ATC SITE NAME: MORLEY 1
 ATC SITE NUMBER: 383495
 AT&T PACE NUMBERS: MRUTH051679 (LTE 3C),
 MRUTH051687 (5G NR 1SR), MRUTH051705 (LTE 5C),
 MRUTH051691 (LTE 4C), MRUTH051695 (4TX4RX
 SOFTWARE RETROFIT)
 AT&T SITE ID: COU6029
 AT&T FA CODE: 10093580
 AT&T SITE NAME: MOUNT PITTSBURG
 SITE ADDRESS: 15743 PHANTOM CANYON VIEW
 COLORADO SPRINGS, CO 80903

AT&T MOBILITY
 ANTENNA AMENDMENT PLAN

TITLE SHEET

VICINITY MAP

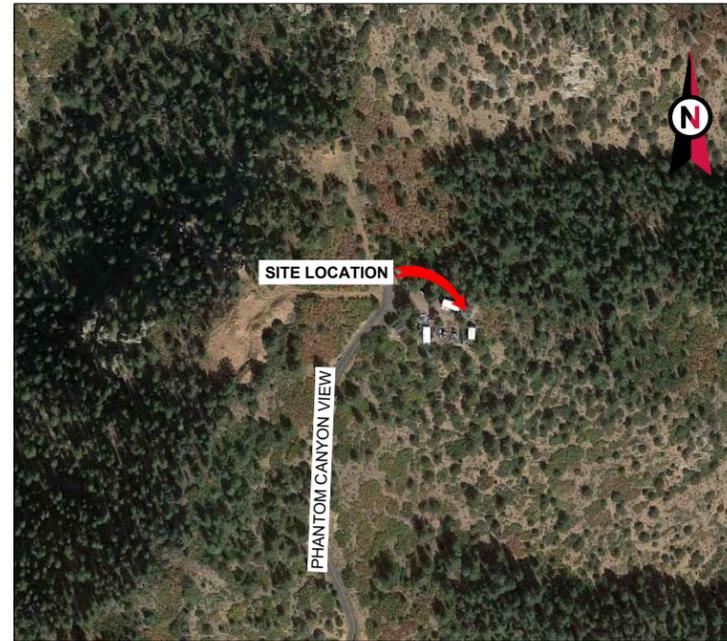
Please include:
 -property tax schedule number
 -legal description
 -lot/parcel size

OVERALL SITE PLAN	
SHEET NUMBER: C-001	REVISION: 0

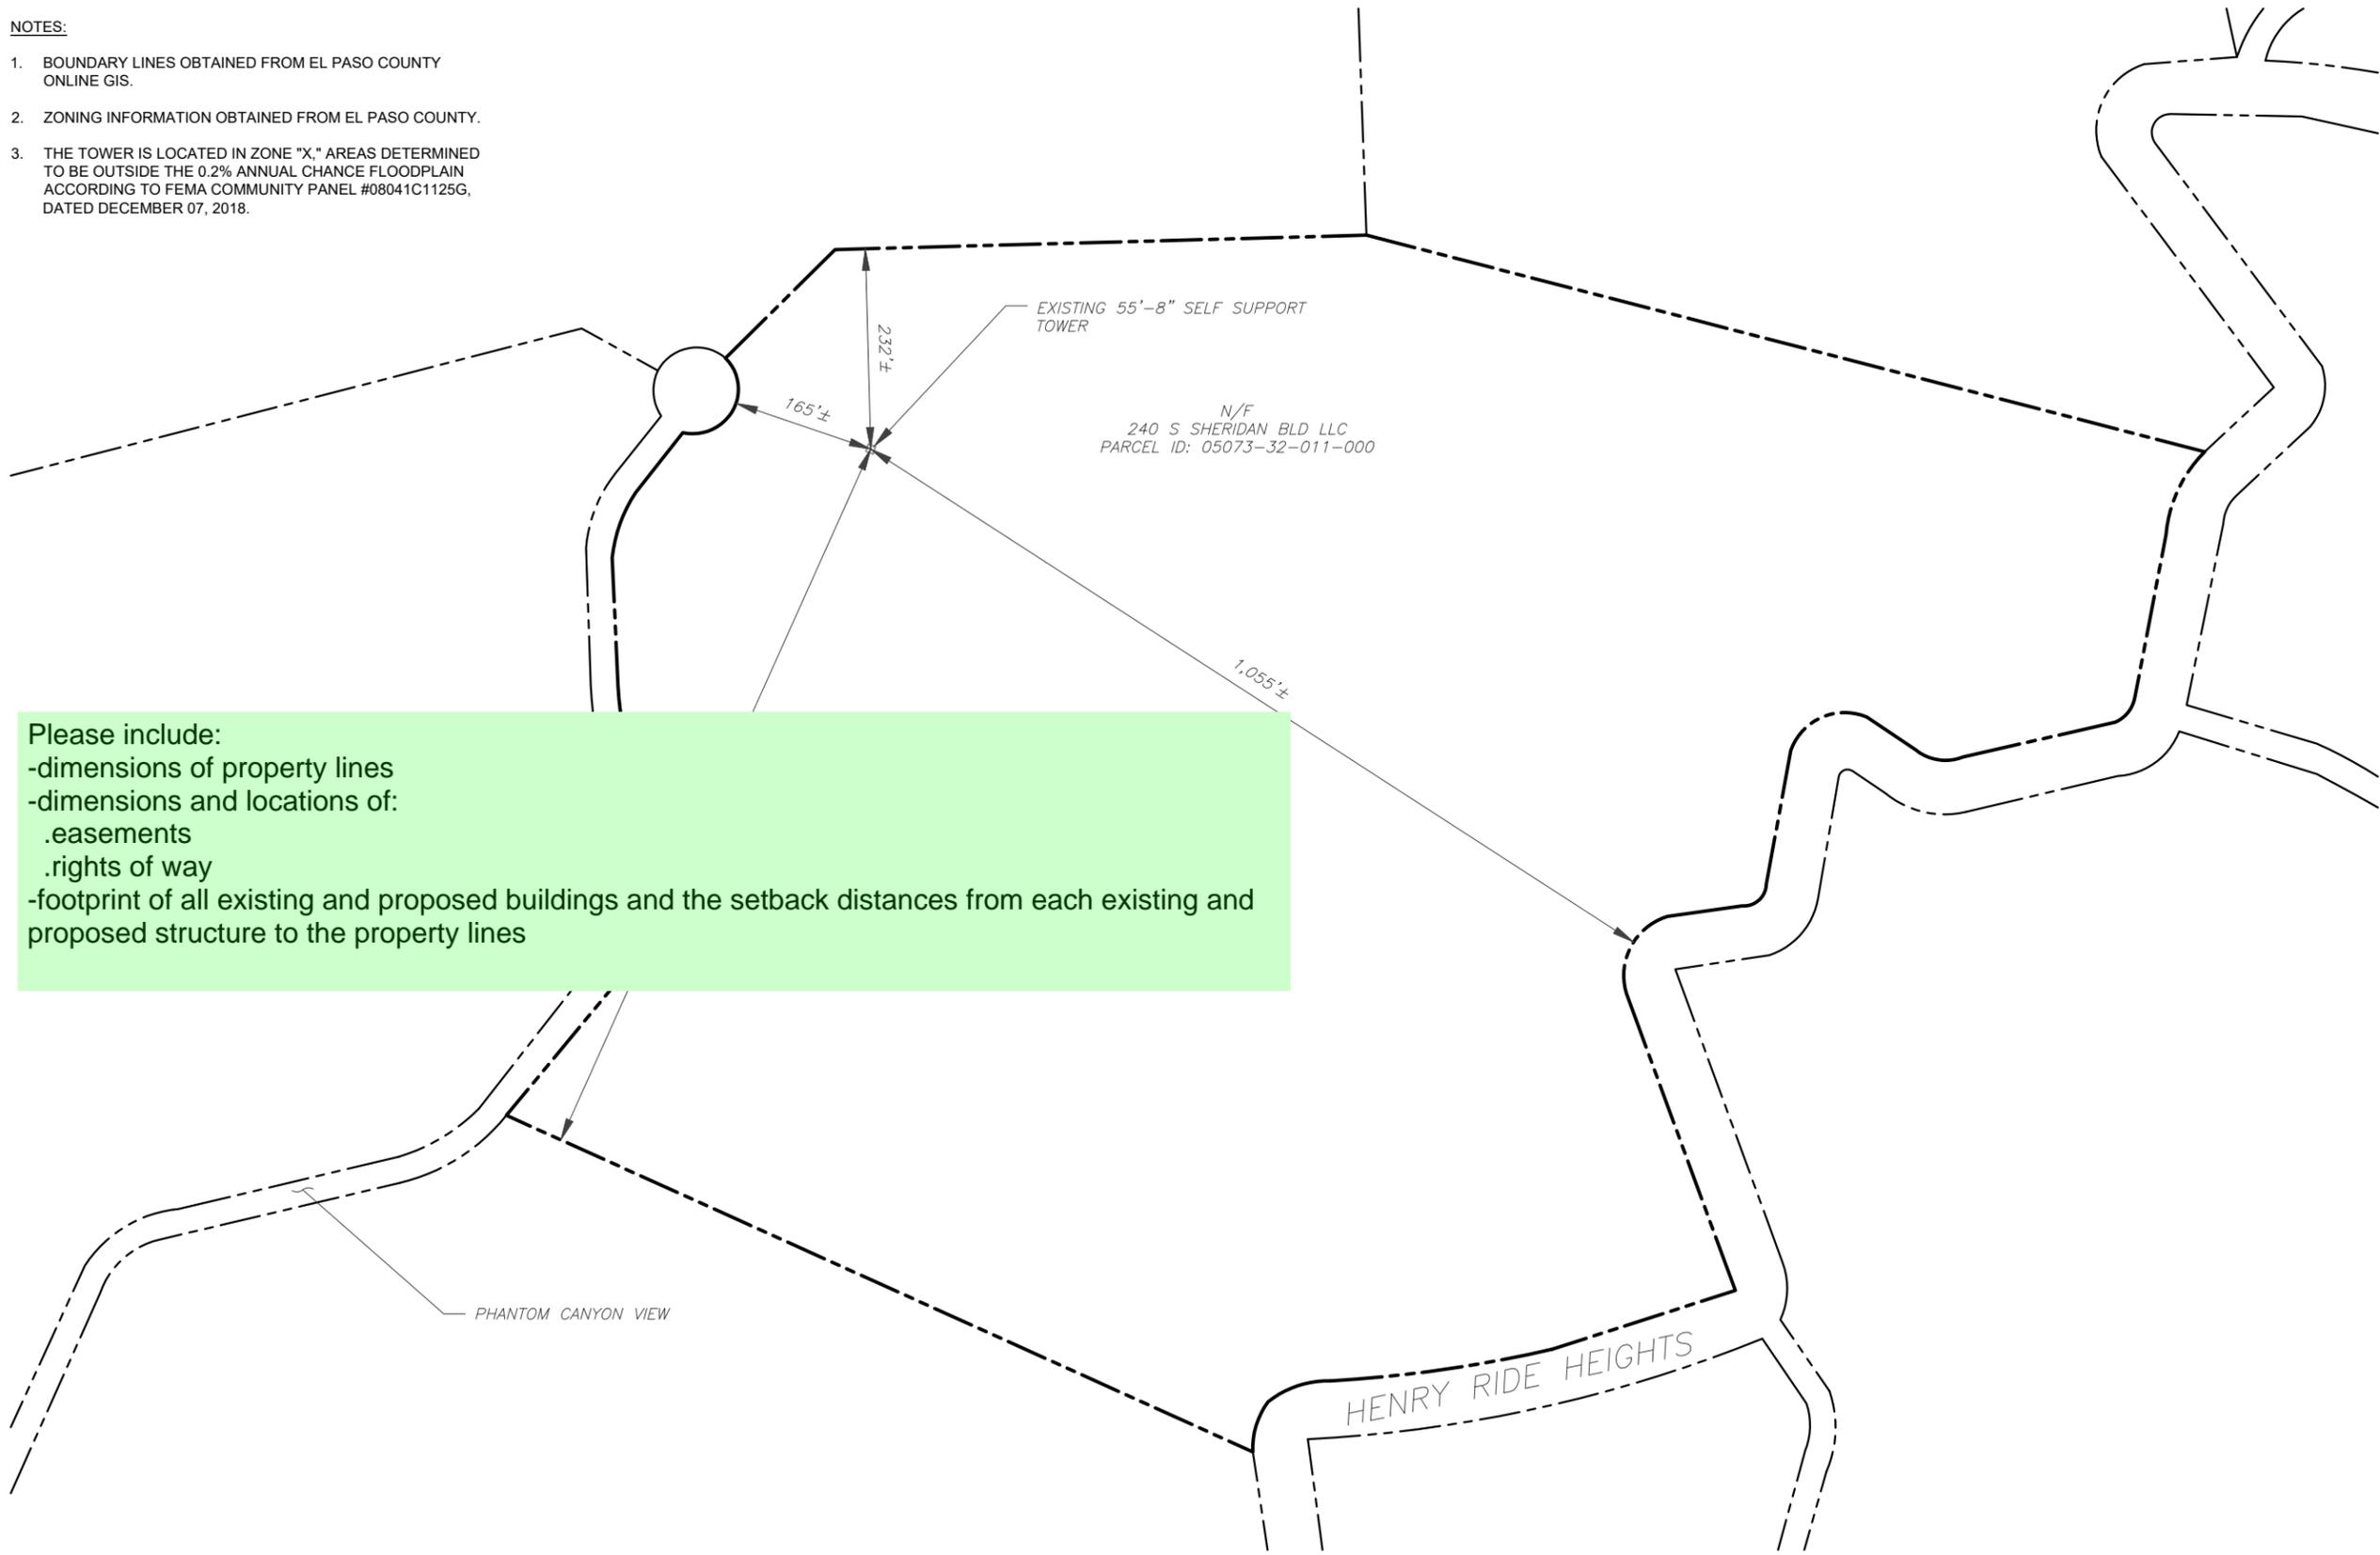
Please include:

- dimensions of property lines
- dimensions and locations of:
 - .easements
 - .rights of way
- footprint of all existing and proposed buildings and the setback distances from each existing and proposed structure to the property lines
